RE: Evans and Associates Construction Co., Inc., Big Fork Ranch Facility
Coal Combustion Residuals (CCR) Landfill, Noble County

Re: Requested Changes to Tier III Permit Application, Big Fork Ranch Coal Combustion Residuals (CCR) Landfill, Noble County

CROSS-SECTION MAP

DRAWING NO: MP-7A SHEET 7 OF 11 REVISED: 3-20-2019

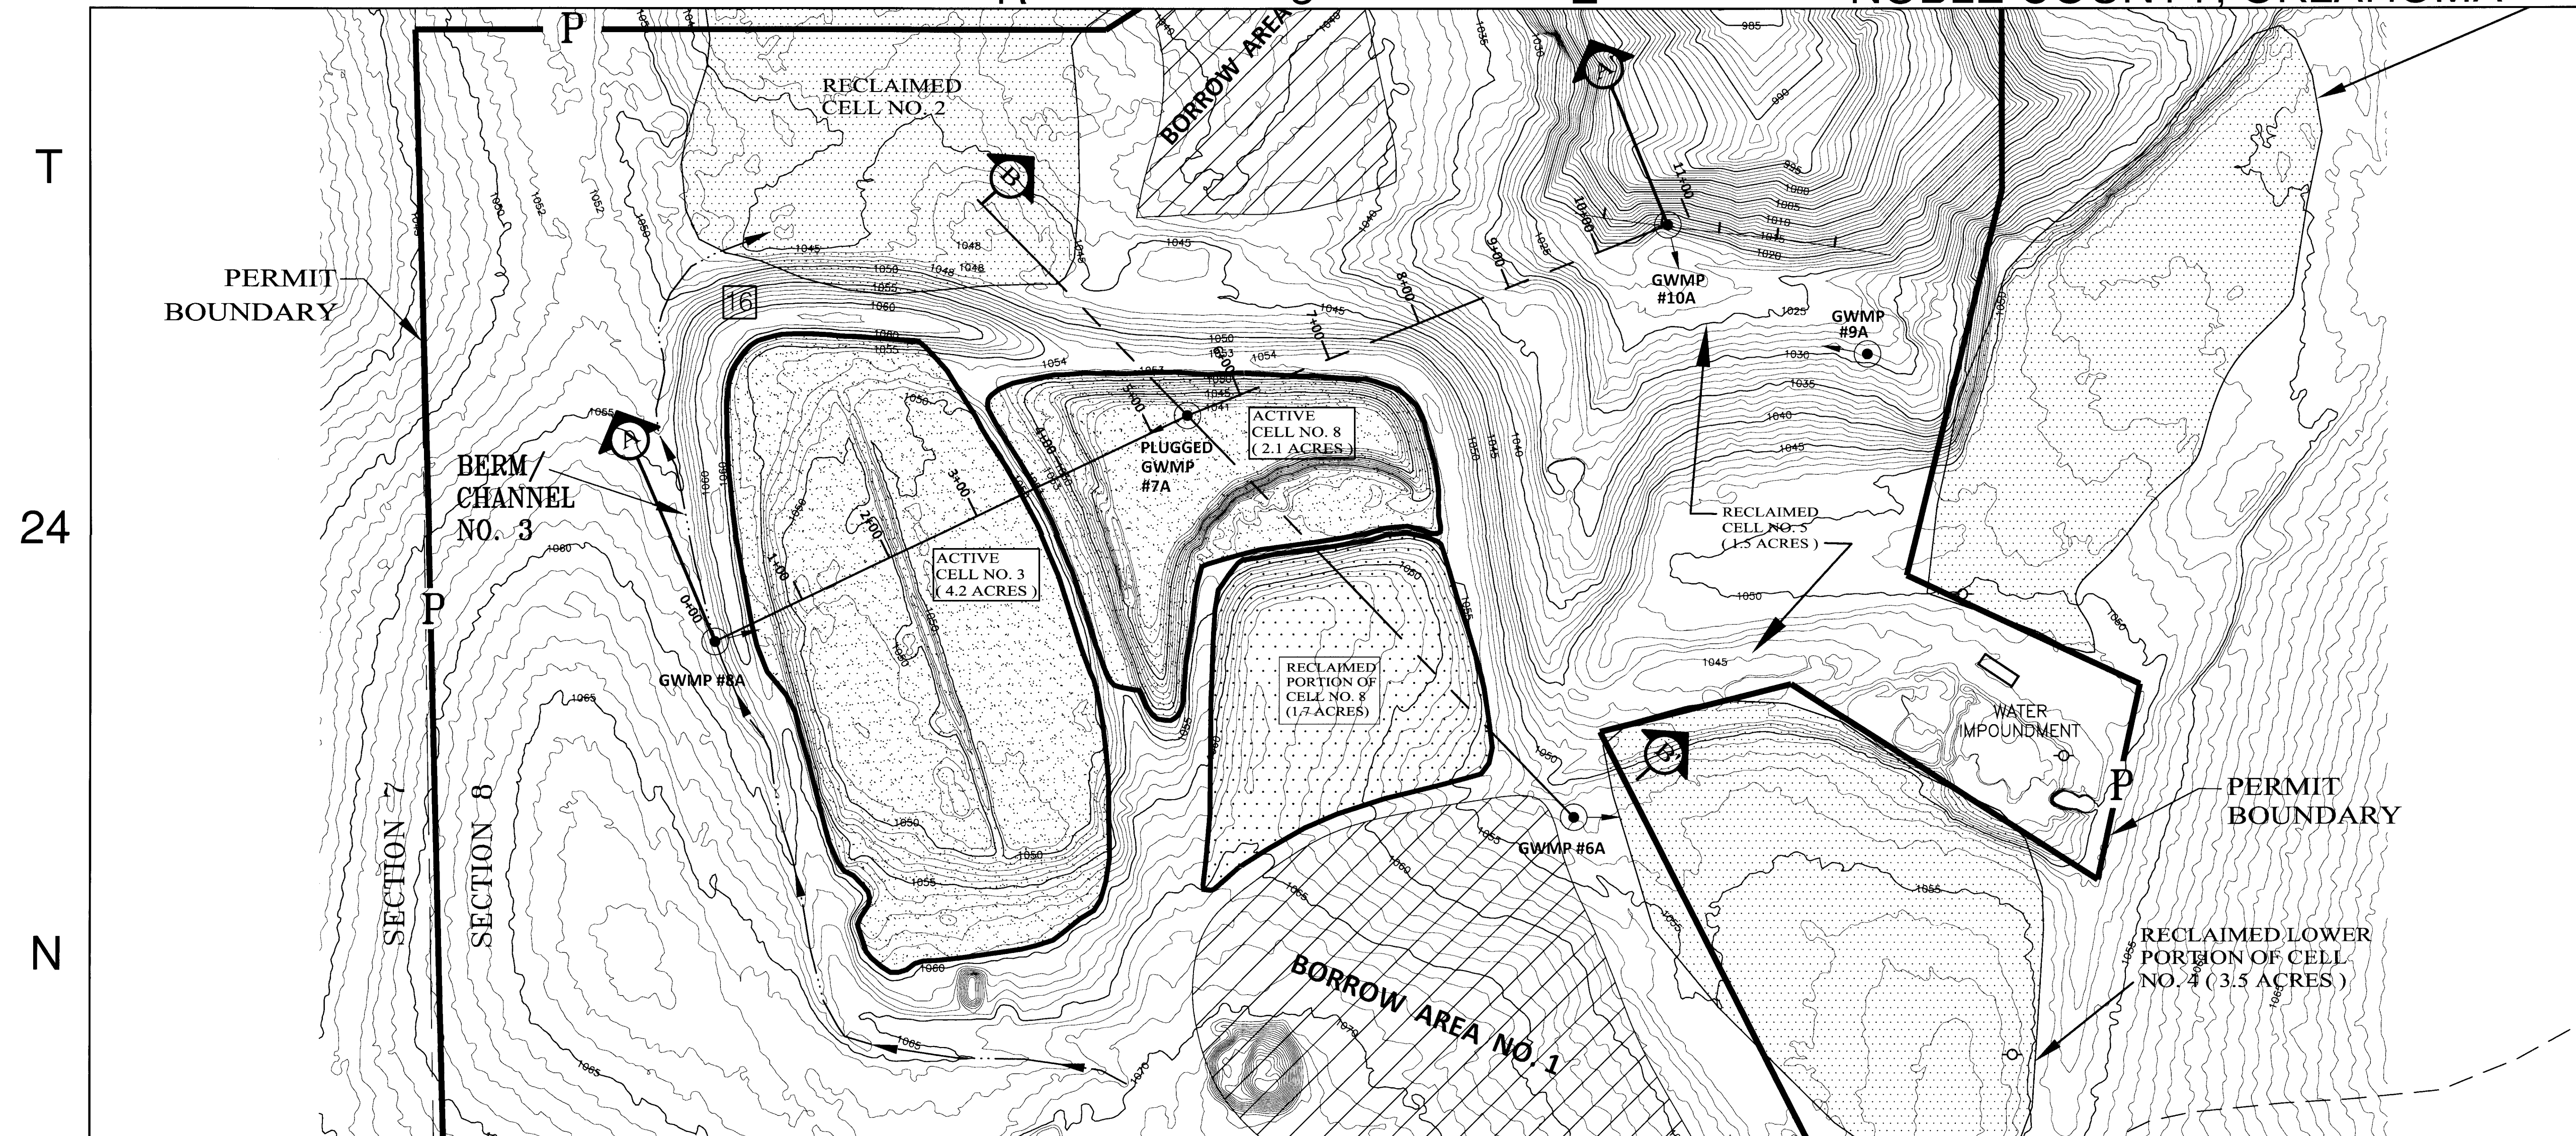
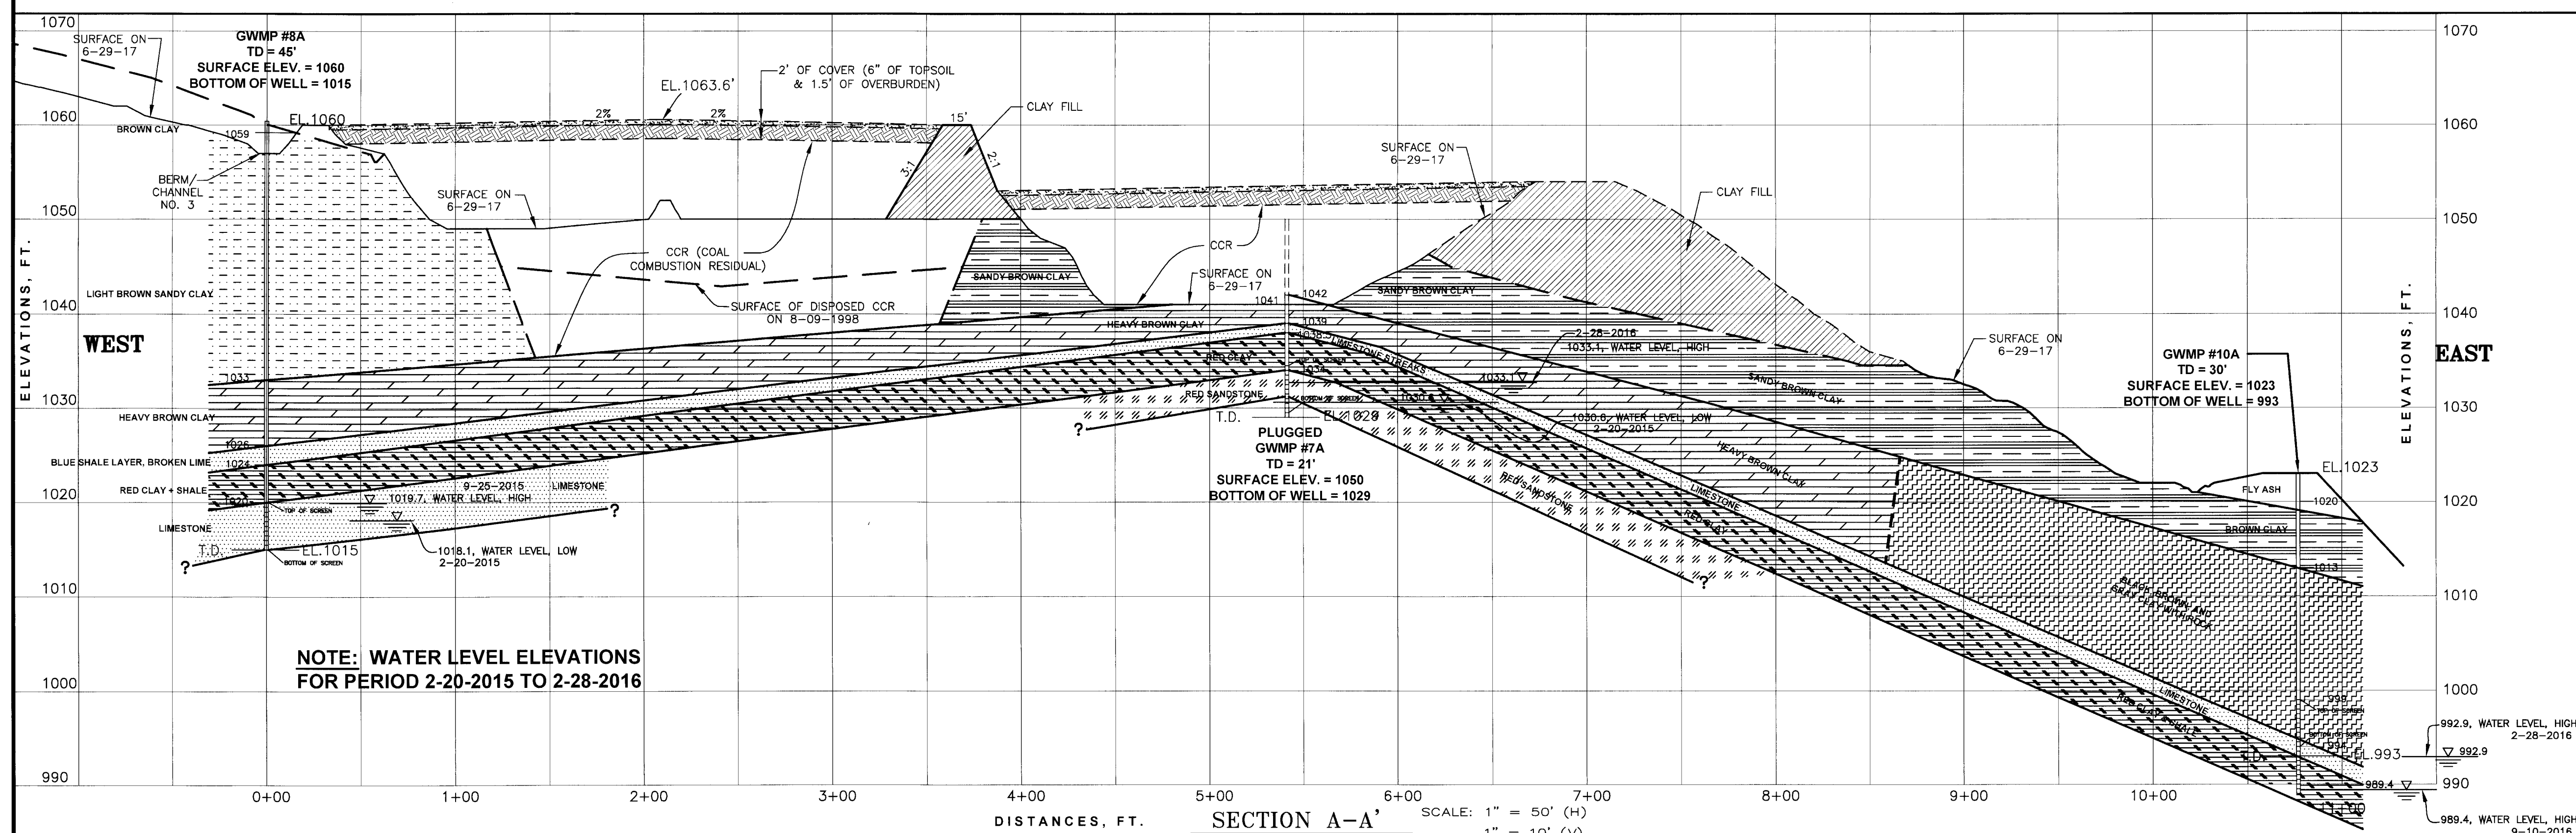
1. Revise MP-7A to clearly depict geological intervals and groundwater elevations on the cross section at GWMP #10A, consistent with the boring log for GWMP #10A provided in Appendix D.
2. Revise MP-7A and MP-7B to specify the dates corresponding to the low water and high water levels at each monitoring well.

On behalf of Evans and Associates Construction Co., Inc. and pursuant to your letter dated March 1, 2019, I submit two revised maps. MP-7A and MP-7B, in support of the CCR permit application. The cross sections on the enclosed maps reflect comments from the Department dated March 1, 2019. Map MP-7A was revised to show geologic strata and groundwater elevations at well GWMP-10A. Maps MP-7A and MP-7B were revised to display the dates of corresponding high and low water elevations.
